HEARING REPORT

**207 TI RAKAU DRIVE, PAKURANGA HEIGHTS
(EB3R)**

**AUCKLAND TRANSPORT
IN CONJUNCTION WITH
EASTERN BUSWAY ALLIANCE**

Figure 4: Retaining wall RW211 located adjacent to 101 Ti Rakau Drive. Esplanade reserve highted in light blue.

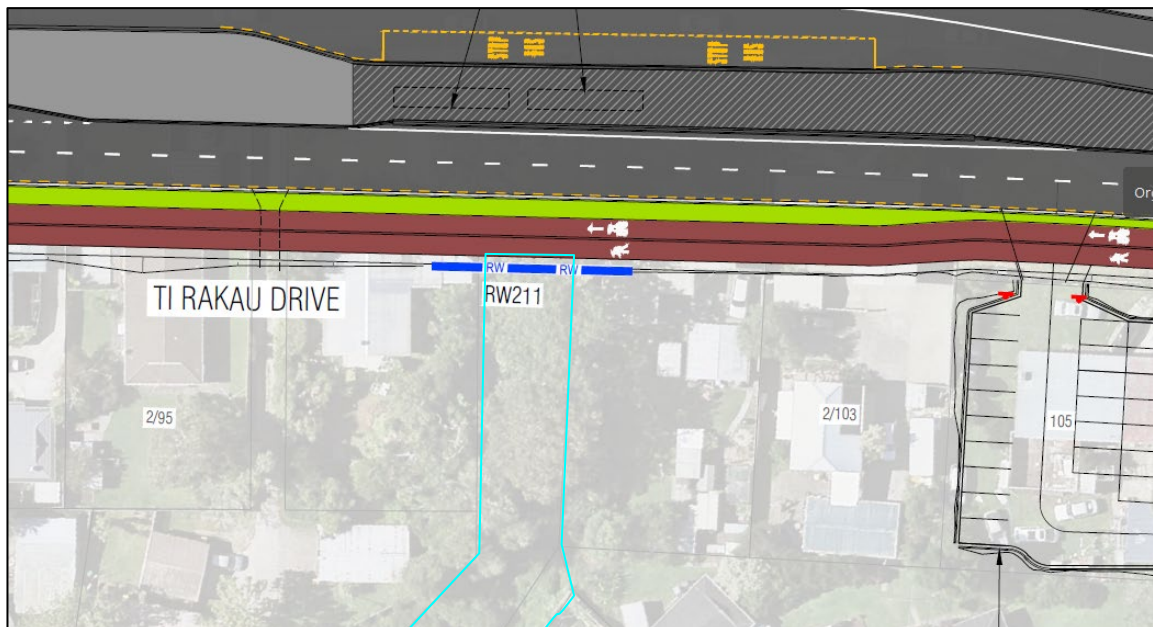
length of 20m⁵. Whilst there is limited public access to this part of the reserve now, the introduction of the wall has the potential to constrain the delivery of a recreational walking and cycling connection in accordance with the HWCN plans. This is not supported and has the potential to diminish the potential future public use and enjoyment of the esplanade reserve - being presently unmitigated. A cross-section of this area might have assisting in understanding this further. **Figure 4** shows the location of the wall. The UDPL condition could be updated to include a review of this wall but there is presently insufficient information available to understand how the wall would maintain future public access.

- 6.18. A large tree would be removed from the northern part (adjacent to the existing bus-stop) of the esplanade area to complete the works, but its loss would be mitigated over time by the proposed 3:1 replacement planting offered by the applicant.

Figure 5: New Parking Area at 105 Ti Rakau Drive (Source: ITA)

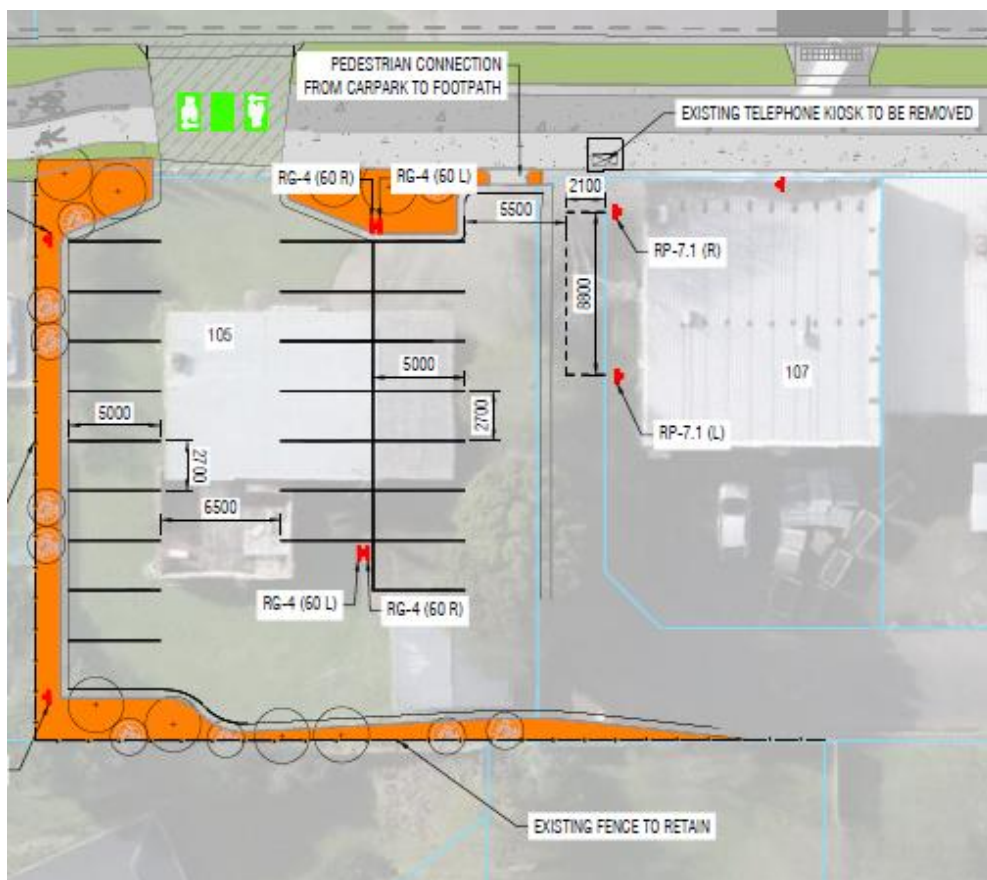
- Reduce the vehicle crossing width to 6m
- Undertake amendment to the internal layout to achieve full compliance in accordance with Table E27.6.3.1.1 (T120), e.g., shifting the manoeuvring space between western rows to make room for the eastern row
- Include appropriate lighting provisions in a manner that complies with the rules in E24 of AUP-OP
- Provide at least one assessable parking space in accordance with NZS:4121-2001.

43. Detailed plans must be submitted for approval to Council of the 22 at-grade public carpark at the above address. These plans must include the following information:
- a) Reduce the vehicle crossing width to 6m
 - b) Undertake amendment to the internal layout to achieve full compliance in accordance with Table E27.6.3.1.1 (T120), e.g., shifting the manoeuvring space between western rows to make room for the eastern row
 - c) Include appropriate lighting provisions in a manner that complies with the rules in E24 of AUP-OP
 - d) Provide at least one assessable parking space in accordance with NZS:4121-2001.

Figure 1 Proposed intensive residential zoning along Ti Rakau Drive, extending across whole catchment

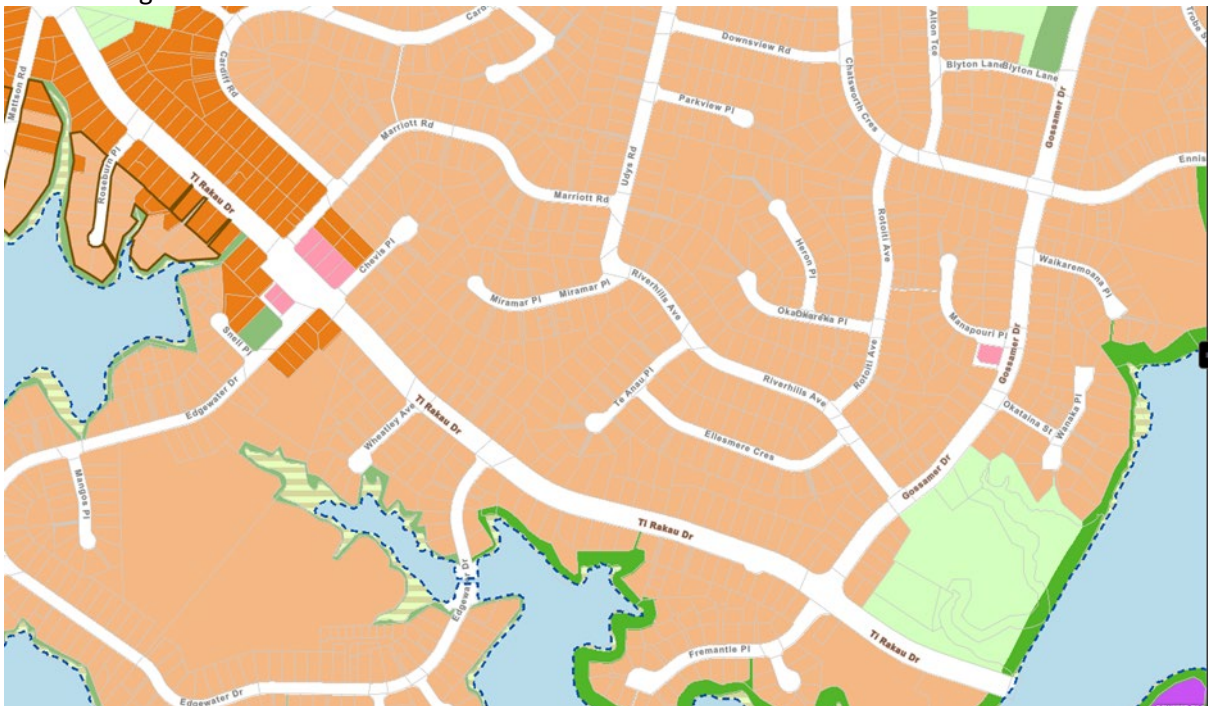
The urban design implications of that three storey intensive re-development flanking Ti Rakau Drive, and five or more storey adjacent to the Pakuranga Plaza, include increased vulnerability to loss of the larger trees on private land, and a greater need for larger trees within the public realm, on streets and in parks. The wider scope of residential intensification will also mean many more people within the walking catchment of the busway stations.

Figure 2 Screenshot Few street trees northern side of Ti Rakau Drive

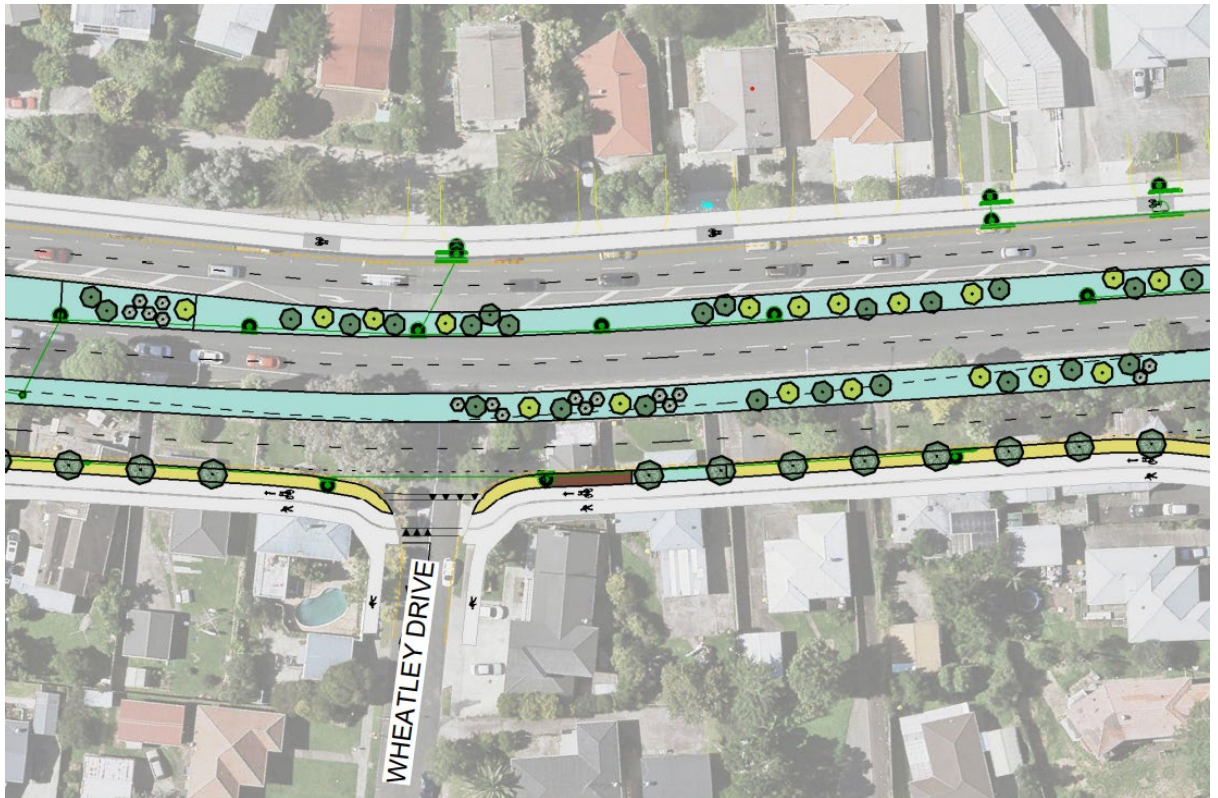
- 4.39. There are also considerable stretches of Ti Rakau Drive with no large or medium street trees proposed, and particularly along the northeastern side of the road, where there is little new land taken and the existing berm appears to be largely taken up by walking and cycling facilities. AEE at 3.2.1 states there will be eastbound existing footpath to remain, a new 2.0m wide segregated cycleway and a 1.0m berm separation from traffic lanes. The AEE accompanying reference diagram Figure 3-2 is not of the general road cross-section but of a Ti Rakau Drive Bus Station, with an existing 3.5m footpath and berm to remain and a new 2.0m wide cycleway with an additional 1.0m separation from the traffic lane.

- 4.40. Figure 2 below shows a sample of Ti Rakau Drive proposed street tree planting (from AEE Appendix 5 Landscape, Ecological & Arboricultural Mitigation Plans), with a scarcity of large trees, or any trees along the northeastern side of parts of Ti Rakau Drive. The small green dots on the northeastern side are not trees, but are not referenced in the plan legend, so may be from some other infrastructure asset map. The footpath and cycleway appear to take up almost the whole of the northeastern berm. This effect is exacerbated by the counting of privately-owned trees as being retained and the dismissal of quantities of unprotected (smaller) street and parks trees by removal as a permitted activity or permitted baseline: The Applicant's Master Tree Plan (AEE Appendix 16) shows street trees in red to be removed and both public and private trees in green to be retained. Many of these private trees "to be retained" are outside of the control of the Applicant, are not protected by any rule in the AUP-OP, and will be vulnerable to loss when intensive redevelopment of those properties occurs.

- 4.41. Along Ti Rakau Drive, from its intersection with Pakuranga Road, there are few new street trees proposed along the western side of the road, with all being allocated to the eastern side of the road or within medians and traffic islands. There is a narrow grassed berm along the western side, mainly in the existing location of the road edge, and not really usable for tree planting as it is directly adjacent to the kerb and trees would hang over the road. The Ti Rakau Corner Reserve at the intersection has some large trees. Then moving southeast along Ti Rakau Drive, the AEE Appendix 16 Arborlab Master Tree Plan shows 12 trees to be removed along the west side of the road, and no new trees (in AEE Appendix 5 Landscape, Ecological and Arboricultural Mitigation Plans) on the street edge until the reserve adjacent to the Ti Rakau Drive Off Ramp at SEART. SEART and the southeastern side of Reeves Road are the boundary between EB2 and EB3R. Then it is along the EB3R western edge of Ti Rakau Drive another 200 metres before a new street tree is proposed. Moving further southeast along Ti Rakau Drive, there are then a good number of new street trees proposed along the southwest side of the road but a dearth along the northeast side of the road. Again, the berm does not appear to be provided with sufficient width to accommodate new street trees of any substantial scale, being almost wholly taken up with the footpath and cycle facilities. This omission of new street trees along the northeast side of the road continues until the frontage of Riverhills Park at Pakuranga Creek. At Riverhills Park the proposed busway and station occupy the frontage of the park, including removal of the parks trees along that frontage and replacement with a 'potential lizard relocation zone' and some mitigation by fourteen 80L trees in a grove on the esplanade alongside Pakuranga Creek.

Figure 1: Proposed locations where heavy truck movements will avoid during 8.25am - 9.00am and 2.55pm - 3.15pm

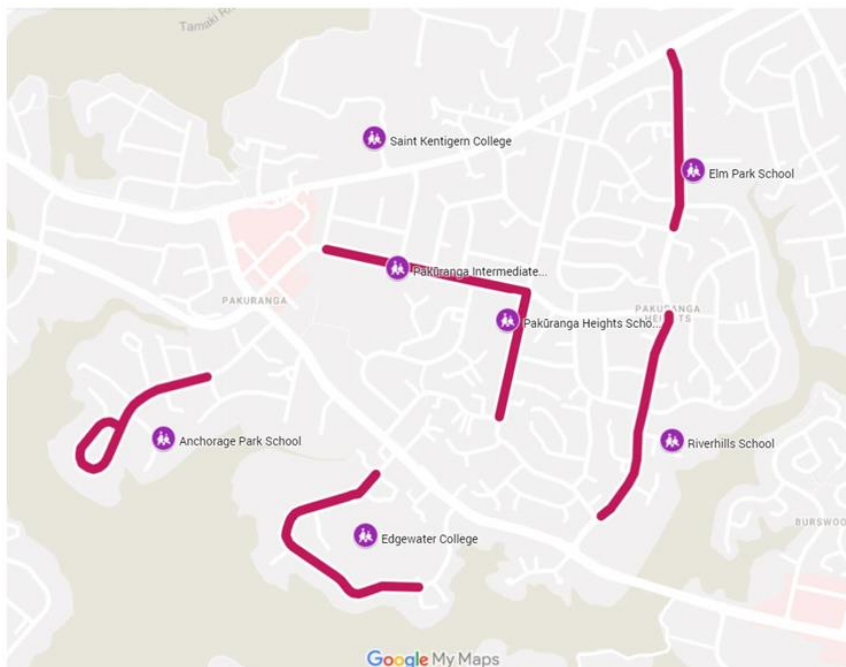
However, the Ministry still have concerns relating to construction traffic around Pakuranga Heights School, Pakuranga Intermediate, Elm Park School and Riverhills School. Reeves Road is an identified construction route for the project. The CTMP states that Reeves Road will carry roughly one construction vehicle every six minutes, either in the westbound or eastbound directions at the peak of construction. Pakuranga Intermediate is located on Reeves

Earlier EB3 Concept:

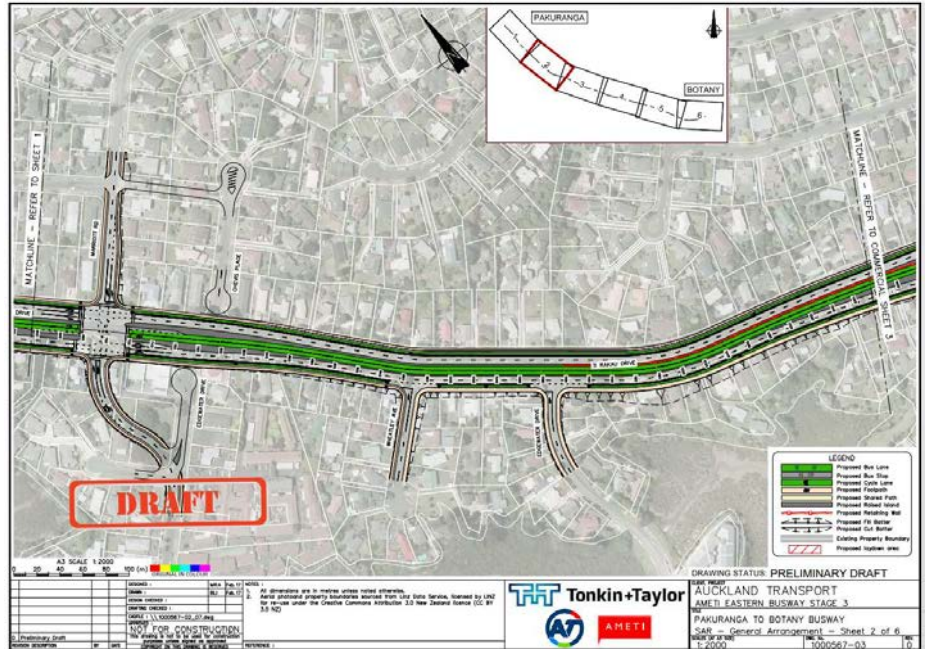
The current proposal removes right turns in/out of both streets. It requires right turning traffic to turn around via signalised U-turn facilities to the east and west.

These right turns could potentially be better catered for if Edgewater Drive (west) is realigned to meet Marriott Road at a single, signalised intersection, as per previous EB3 concepts.
